SUMMARY NOTES OF THE NOVEMBER 7, 2012, MEETING OF THE ROOT RIVER WATERSHED RESTORATION PLAN ADVISORY GROUP

REVIEW OF PARTIAL PRELIMINARY DRAFT CHAPTER IV, "CHARACTERIZATION OF THE WATERSHED," OF SEWRPC COMMUNITY ASSISTANCE PLANNING REPORT NO. 316 (CAPR NO. 316), "A RESTORATION PLAN FOR THE ROOT RIVER WATERSHED"

Figure IV-7

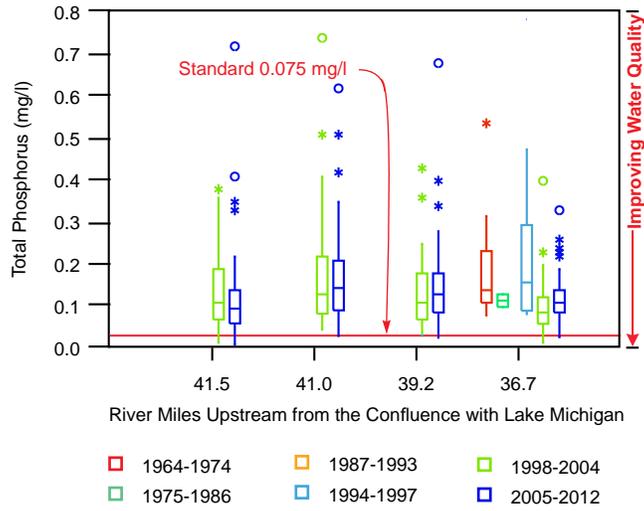
Mr. Boxhorn reviewed box plot concepts and noted that Figure IV-7 summarizes the information that is shown in a box plot.

[Secretary's Note: Figure IV-7 was revised to be specific to the Root River watershed. A copy of the revised figure is included herein as Exhibit D.]
